# Radisson Garments Ltd.

Plot # B-84, BSCIC, Tongi, Gazipur-1710

# Observations

# Heavily-loaded areas

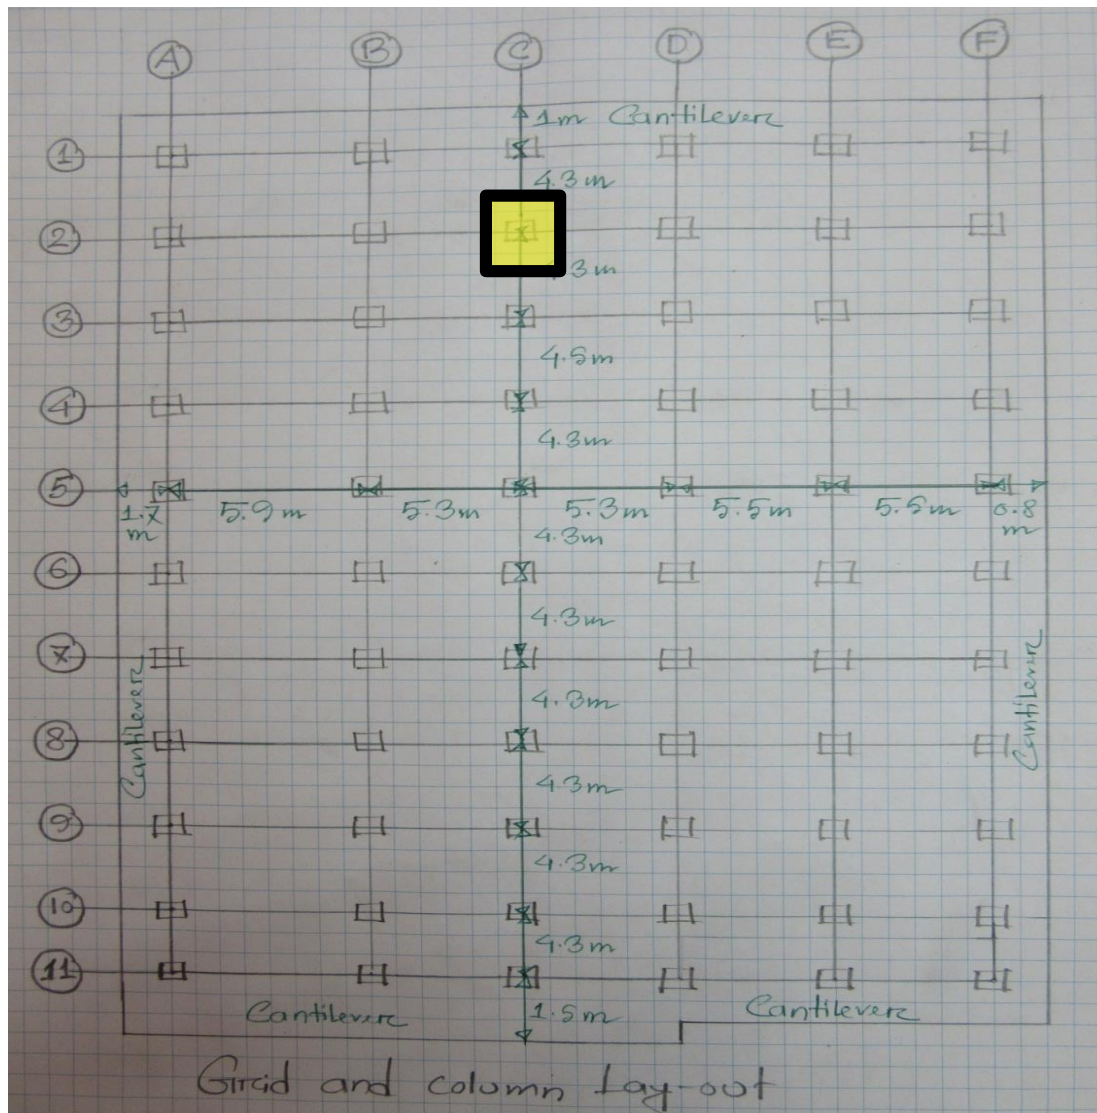
Loading of finished goods on 2<sup>nd</sup> and 1<sup>st</sup> floor level

Item No.	Observation	Recommended Action Plan	Recommended Timeline
9	Heavily-loaded areas	Pending the outcome of the Detail Engineering Assessment (see Item 1), live load to be limited to 1,5 kPa at all levels.	<b>Immediate - Now</b>
10	Heavily-loaded areas	As part of the Detail Engineering Assessment (see Item 1), Building Engineer to confirm design loading of slabs and incorporate it into the loading plan for all floor plates within the Building.	<b>6-weeks</b>
11	Heavily-loaded areas	Continue to implement the load management plan	<b>6-months</b>
12	Apparently small sized load transfer structure.	As part of the Detail Engineering Assessment (see Item 1), Building Engineer to carry out a design check to the load transfer structure on all the floors.	<b>6-weeks</b>
13	Apparently small sized load transfer structure.	Reconstruct or repair load transfer structure as necessary to ensure code adequacy.	<b>6-months</b>

# Apparently small sized load transfer structure

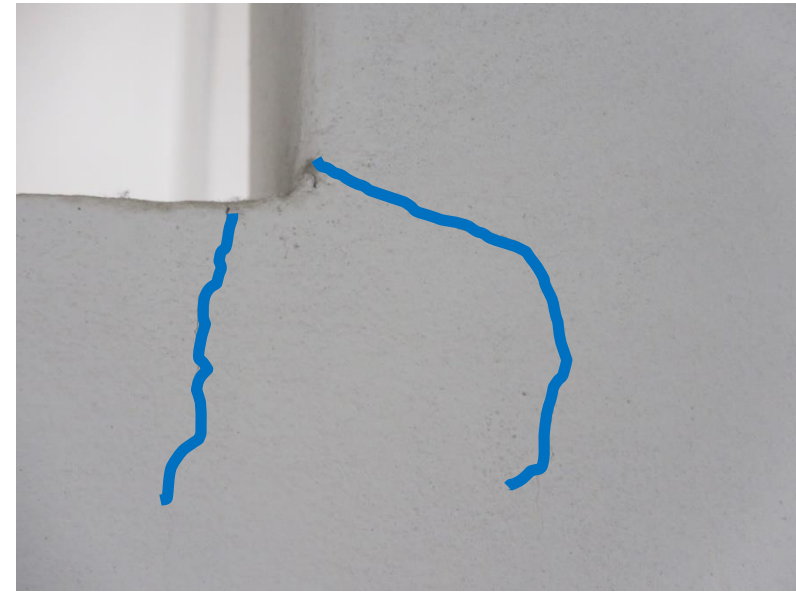
The indicated column is present in the upper floors but absent on Ground, First and Second floors. Instead there are apparently small sized load transfer structure which is not indicate in the Design documentation. In the original design documentation the column is present all the floors.

# Cracks in the structural elements

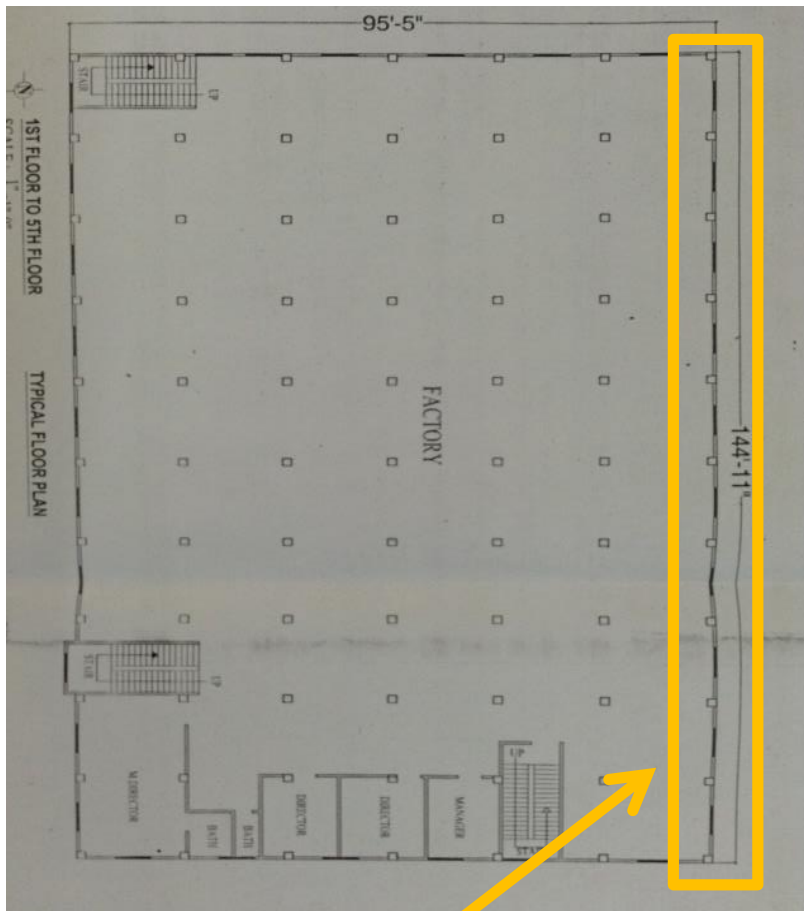
Cracks in different structural elements

14	Cracks in the structural elements	As part of the Detail Engineering Assessment (see Item 1), Building Engineer to investigate the reasons for the crack formation.	<b>6-weeks</b>
15	Cracks in the structural elements	Define the necessary remedial works.	<b>6-weeks</b>
16	Cracks in the structural elements	Monitor cracks to beams, slabs, columns and facades. Engage a Building Engineer to investigate if cracks are only in the internal plastering.	<b>6-months</b>
17	Cracks in the structural elements	Building Engineer to advise on load reduction and repair and strengthening of the structure if required.	<b>6-months</b>

# Discrepancies between permit drawing, design drawings and as-built structure

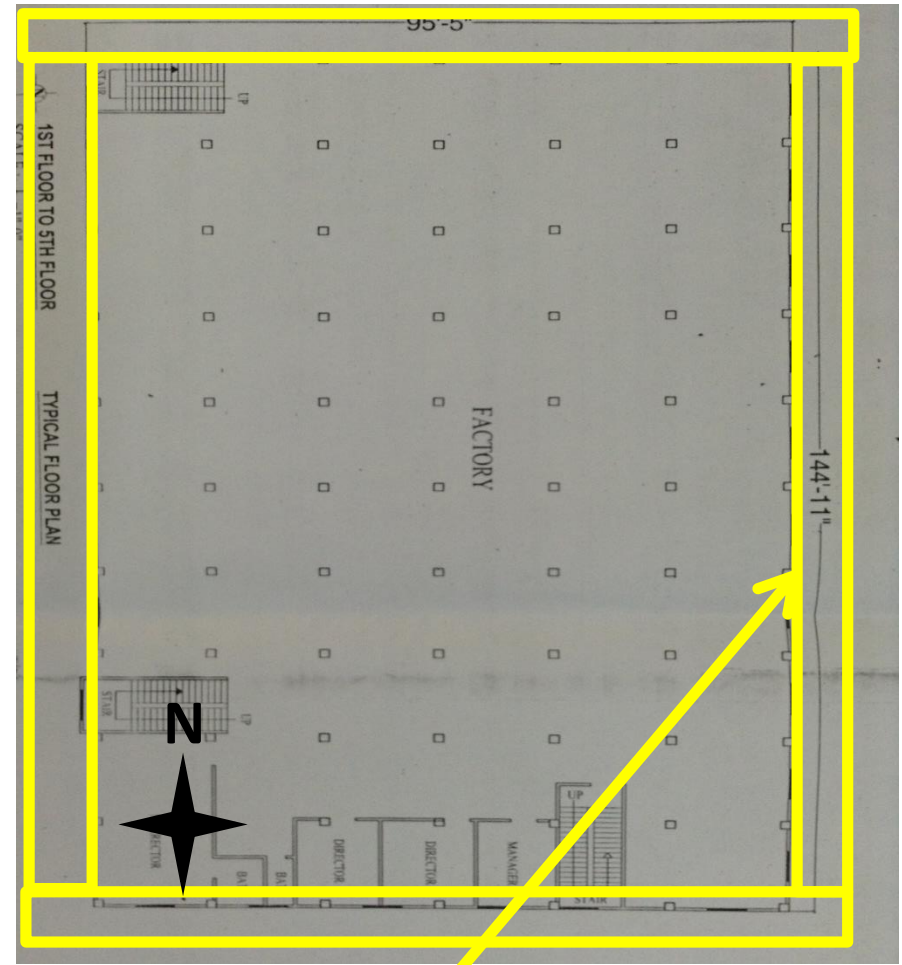
This row of columns shown in the permit drawings is absent in the as-built structure

Cantilevers at four sides (5<sup>th</sup> & 4<sup>th</sup> floor) and at north and east sides (3<sup>rd</sup>, 2<sup>nd</sup> and 1<sup>st</sup> floor) are not shown in the permit drawings

Column dimensions and reinforcement details shown on the drawing schedule differ from what we observed on site

Item No.	Observation	Recommended Action Plan	Recommended Timeline
18	Discrepancies between permit drawing, design drawings and as-built structure	As part of the Detail Engineering Assessment (see Item 1), Building Engineer to survey the as-built structure, including as-built floor finish thickness.	6-weeks
19	Discrepancies between permit drawing, design drawings and as-built structure	Building Engineer to produce accurate as-built drawings.	6-months
20	Non-permitted additional rooftop structures	As part of the Detail Engineering Assessment (see Item 1), Building Engineer to assess the additional rooftop structures in terms of their own engineering robustness and stability, and also their effect on the supporting structures.	6-weeks
21	Non-permitted additional rooftop structures	Repair or remove the additional rooftop structures as directed by the Building Engineer.	6-months
22	Non-permitted additional rooftop structures	Carry out any structural works as required to the supporting structures.	6-months
